Service information SI_2014_103_0073 T3

| Nr | Name | Description | Date |
|--------|---------------------|------------------------------------|------------|
| 03 | SI_2014_103_0073 T3 | Grid detection input | 2014-12-18 |

| | Serial numbers: | Date issued: 2014-12-18 | |
|----------------------|------------------------|--------------------------|--|
| SI_2014_103_0073 T3 | Erik Säll | Jonas Petersson | |

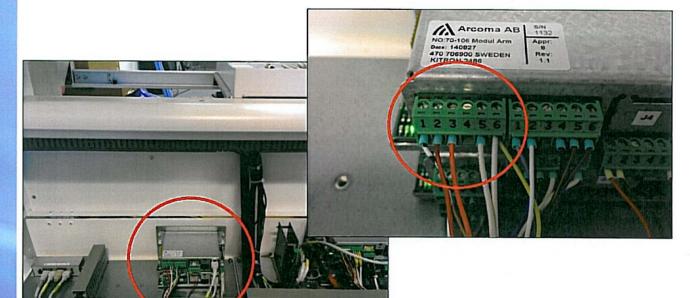
- 1. In systems <u>without</u> collimator sizes in Canon APR's the collimator will not limit the X-ray field to the size of the selected detector. In this situation the X-Ray field can be larger than the detector size.
- 2. In systems with collimator sizes in Canon APR's a problem calculating the stitching image area may appear, see error message below.

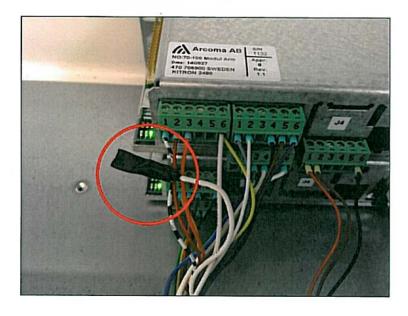
The problem can be solved by disconnecting the wire connected to 2.2CB01 connector J0-5.

Location of the bucky node 2.2CB01 in the 0055-table is shown in the pictures below.

Disconnect the wire connected to 2.2CB01 J0-5. Isolate the conductive part of the wire and hide it in the cable channel.
